Access Compliance Report

Public Rights-of-Way

Intersection ID: 42401	Main Street: GRIERS GROVE RD	Cross Street: MCALLISTER DR	Location: SW
ADA ID: A8D0B10E7B7C	Ramp Type: PerpDiag	Initial Pass/Fail: Fail	Overall Compliance: No
		Severity Score: 30

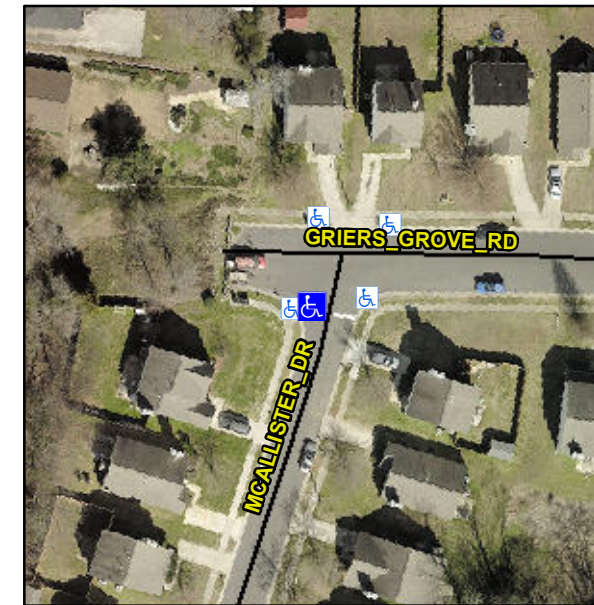
Not Found, R304.5.1, R304.2.2

Compliance	Description	Data	Compliance	Description	Data
N/A	Ramp Length (in)	52.0	No	Ramp Slope (%)	8.4
No	Ramp Width (in)	34.0	Yes	Ramp XSlope (%)	1.9
N/A	Flare Type LT	N/A	N/A	Flare Type RT	N/A
N/A	Flare Slope LT (%)	N/A	N/A	Flare Slope RT (%)	N/A
N/A	Flare Traversable LT?	N/A	N/A	Flare Traversable RT?	N/A
N/A	Landing Length (in)	N/A	N/A	DWS Provided?	N/A
N/A	Landing Width (in)	N/A	N/A	DWS Contrast?	N/A
N/A	Landing Slope (%)	N/A	N/A	DWS Length (in)	N/A
N/A	Landing X Slope (%)	N/A	N/A	DWS Full Width?	N/A
N/A	Landing Curb? (Y/N)	N/A	N/A	DWS Offset (in)	N/A
N/A	Shared Landing?	N/A			
N/A	Gutter Ponding?	N/A	N/A	Gutter Slope (%)	N/A
N/A	Gutter Lip Ht (in)	N/A	N/A	Gutter X Slope (%)	N/A
N/A	Painted X Walk1?	No	N/A	Painted X Walk2?	No
	X Walk 1 Direction	To E		X Walk 2 Direction	To N
N/A	X Walk 1 Width (in)	N/A	N/A	X Walk 2 Width (in)	N/A
	X Walk 1 Slope (%)	3.7		X Walk 2 Slope (%)	4.0
	X Walk 1 X Slope (%)	2.2		X Walk 2 X Slope (%)	4.0

Remove & Replace Curb Ramp With Two New Directional Ramps or Equivalent.
